Drain Kit Solution

B5109 for 2.3 MW cylinder MK II

Original rod seal system, without pressure relief/drain line. New rod seal system, with pressure relief/drain line.

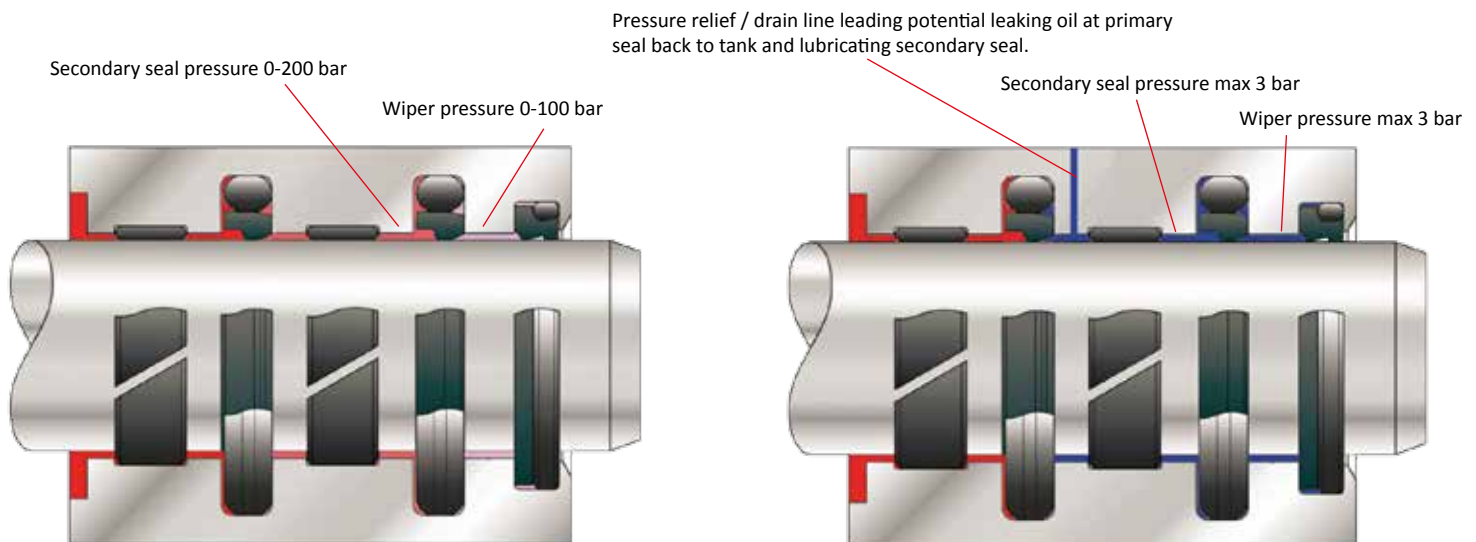
Seal system with low overall wear rate on rod and seals will significantly reduce the risk of leakage into hub by leading potential leakage at primary seal back to tank.

Pressure is thereby reduced from 0-200 bar to 0-3 bar on the secondary seal. Also, the contaminated oil is led back to tank, which again causes less wear on seals and rod.
